Proposed Elevations

26/06/26 REVISED
Mr & Mrs Tolan
5 Tanners Row,
Wokingham,
RG41 4EL

Design Review 26/08/2026

Proposed GF Plan

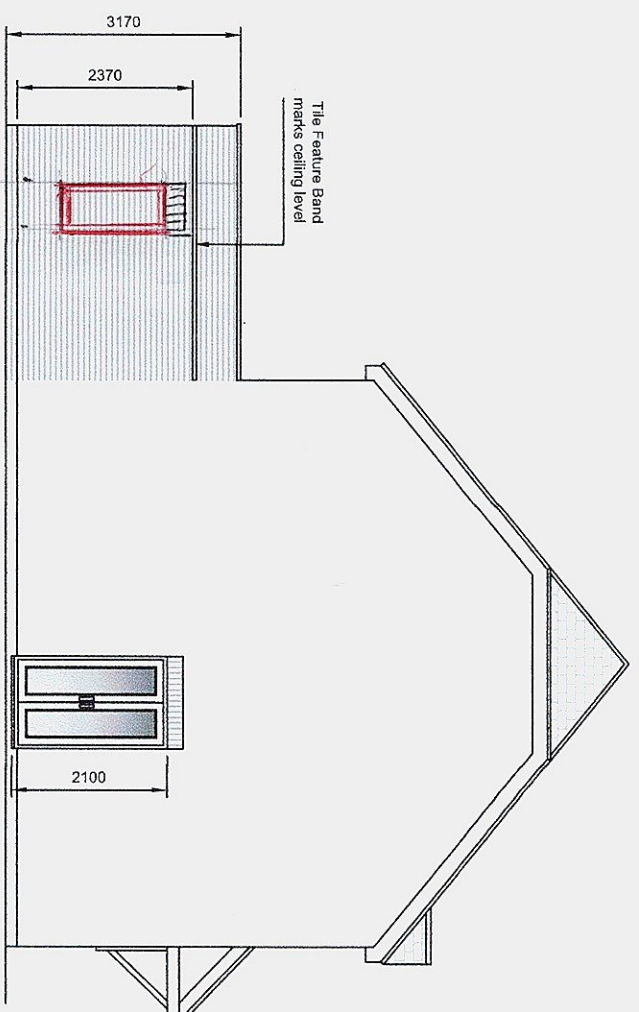
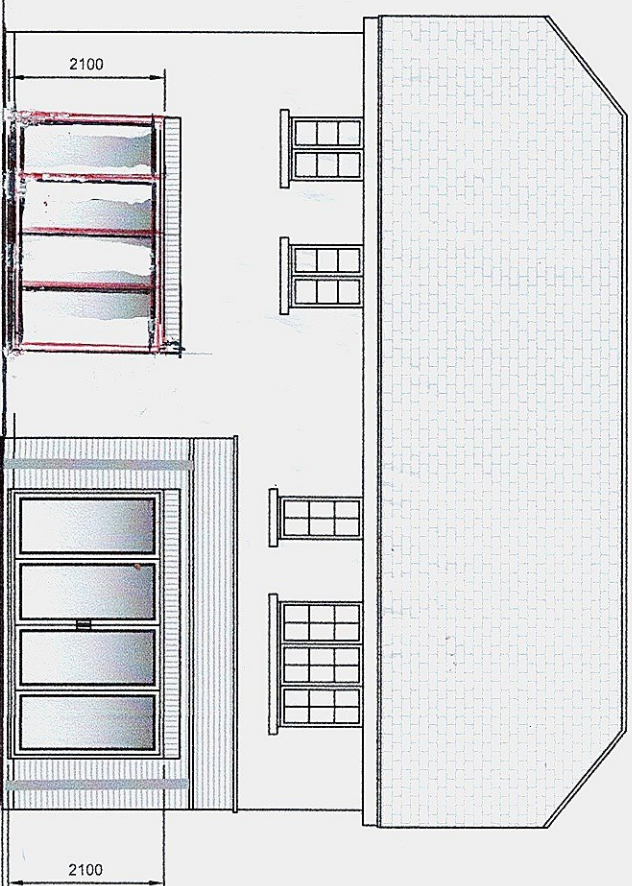
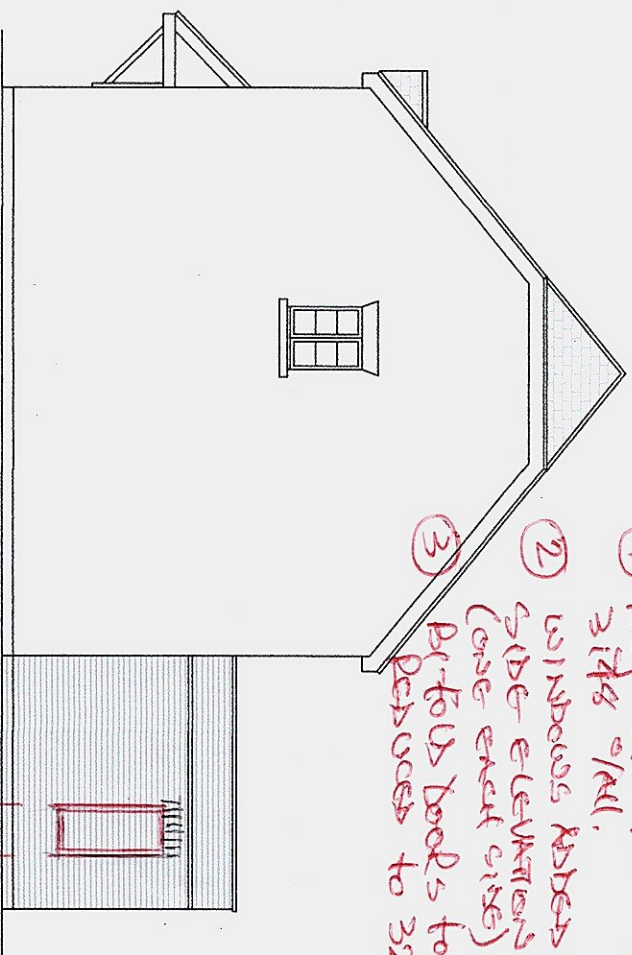
26/06/26
REVISIONS.
① PROJECTION REDUCES TO 3148 W/ALL.
② WINDOWS ADDED TO SIDE ELEVATION (ONE EACH SIDE)
③ BIFOLD DOORS TO LOUNGE REDUCES TO 3250 WIDE

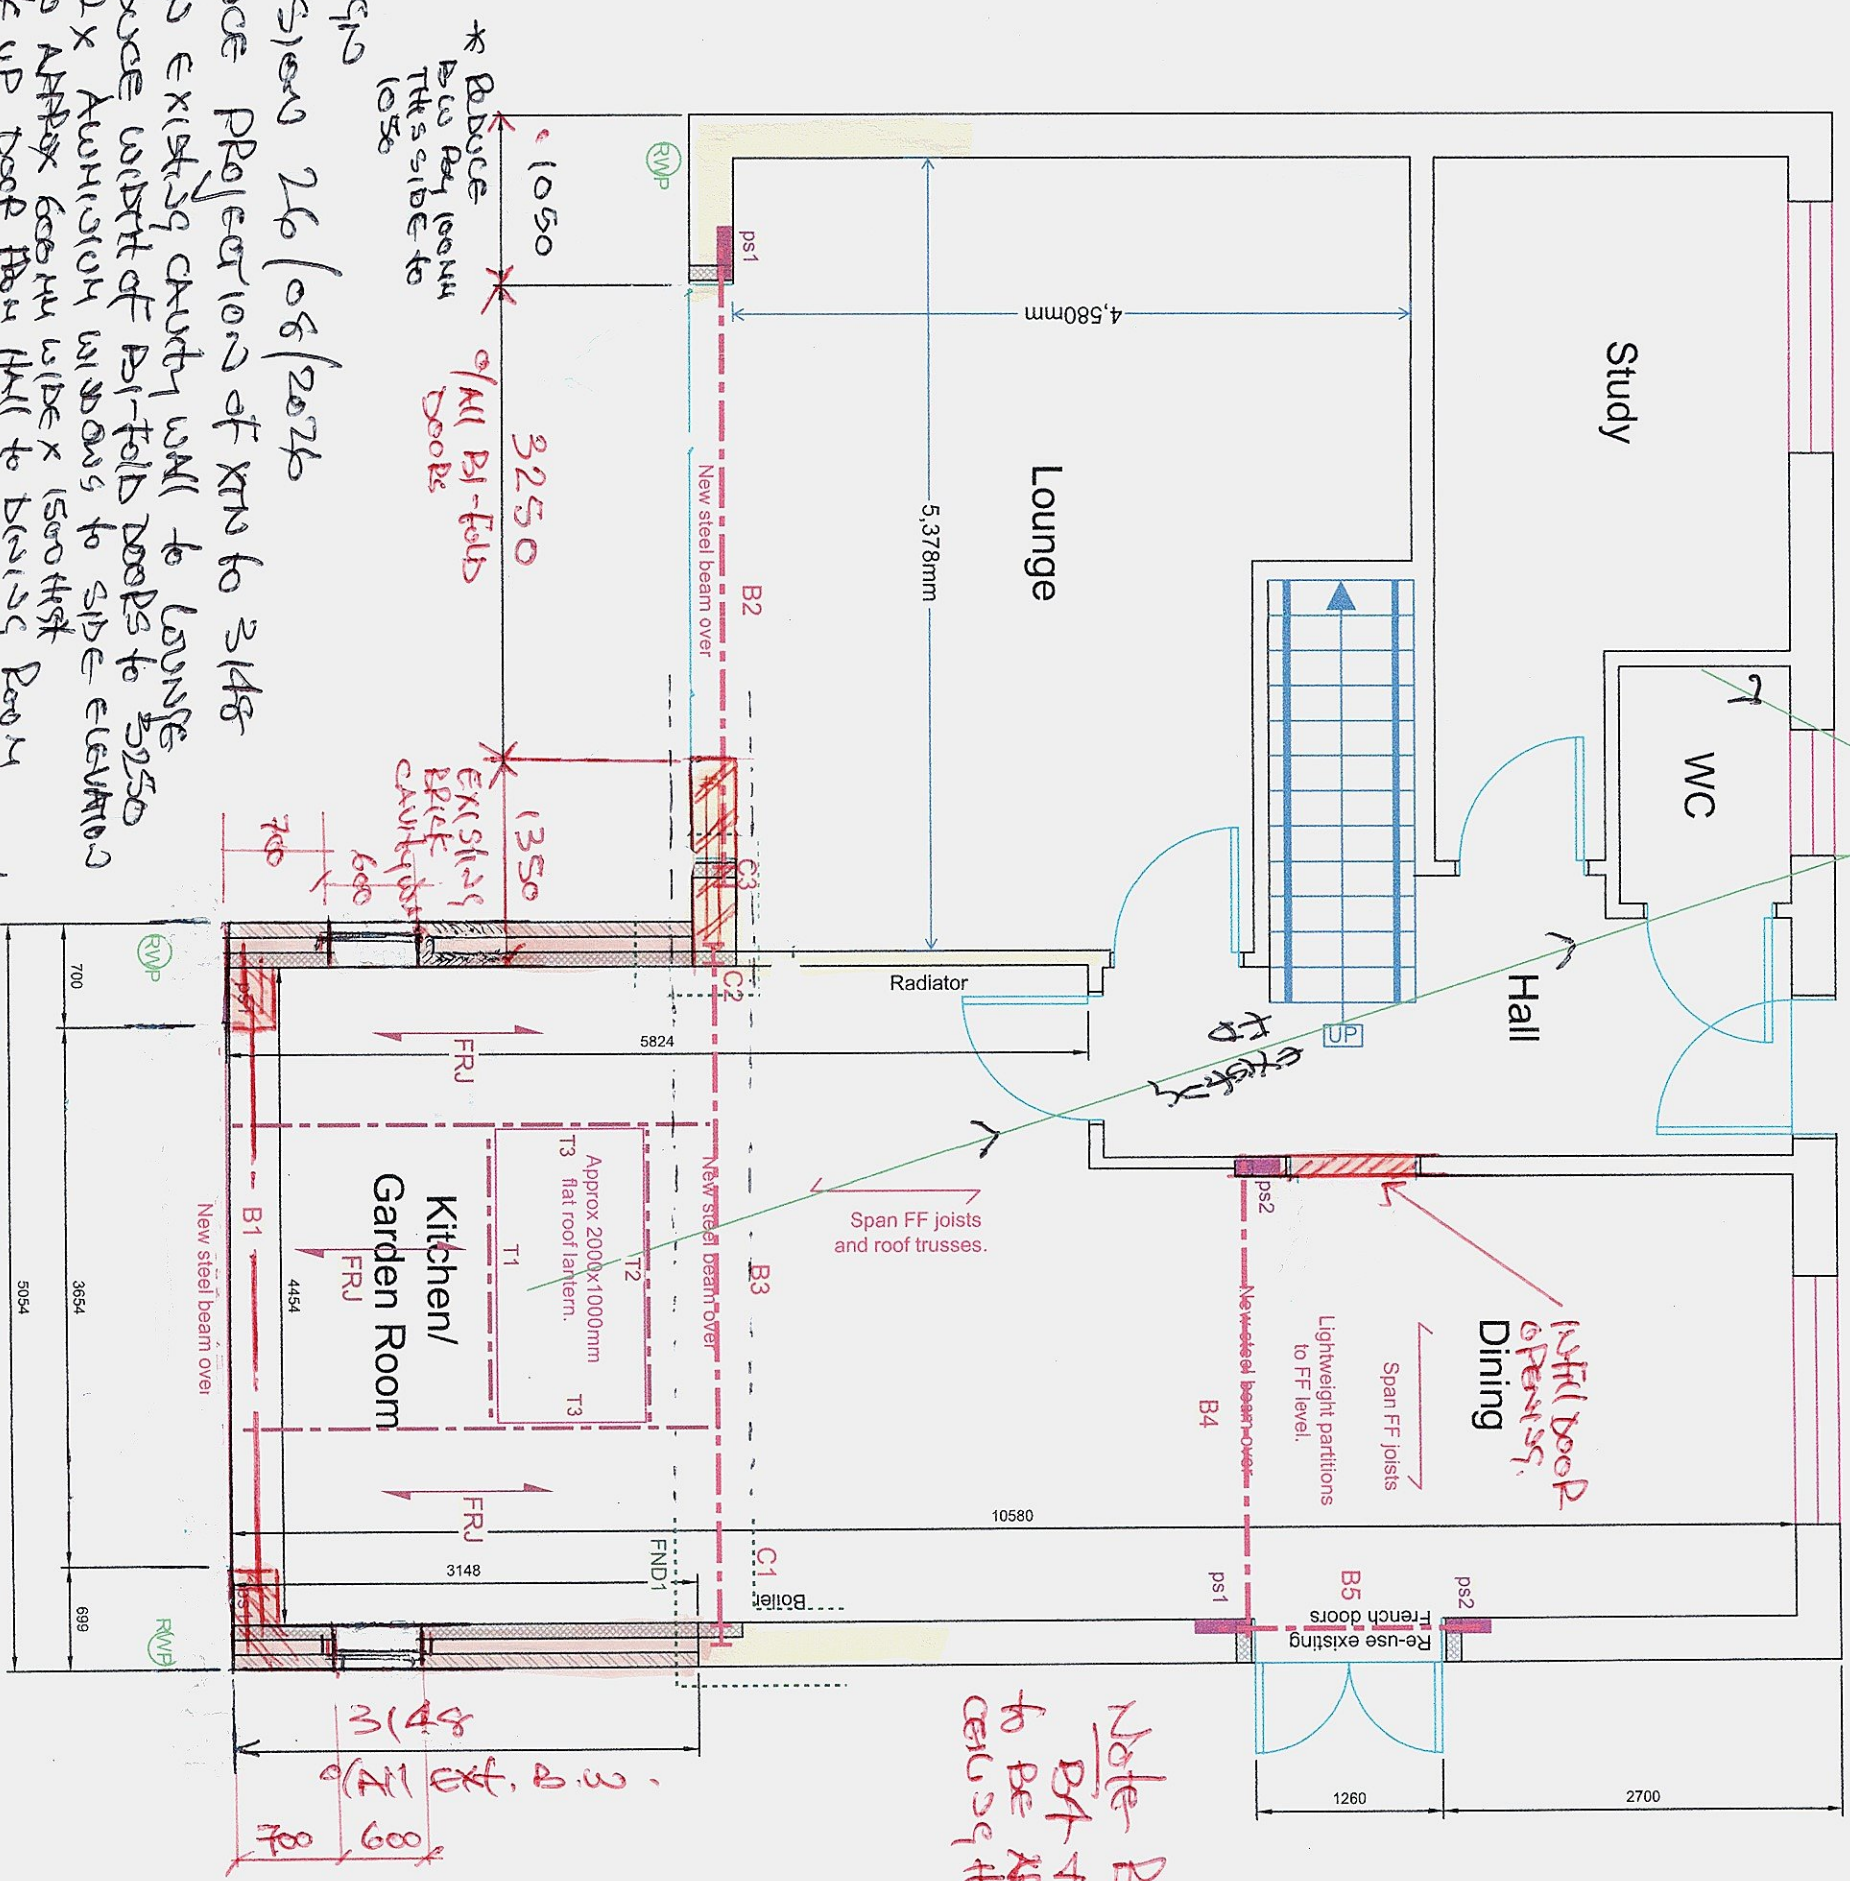
Note Beams B4 + B5 to be above ceiling etc.

- 1) Reduce Projection of XRD to 3148
- 2) Return existing cavity wall to lounge + Reduce width of Bi-fold doors to 3250
- 3) Add 2x Aluminium windows to side elevation of XRD approx 600mm wide x 1500mm high
- 4) Block up door from Hall to Dining Room
- 5) Beams B3 + B4 to finish above ceiling etc
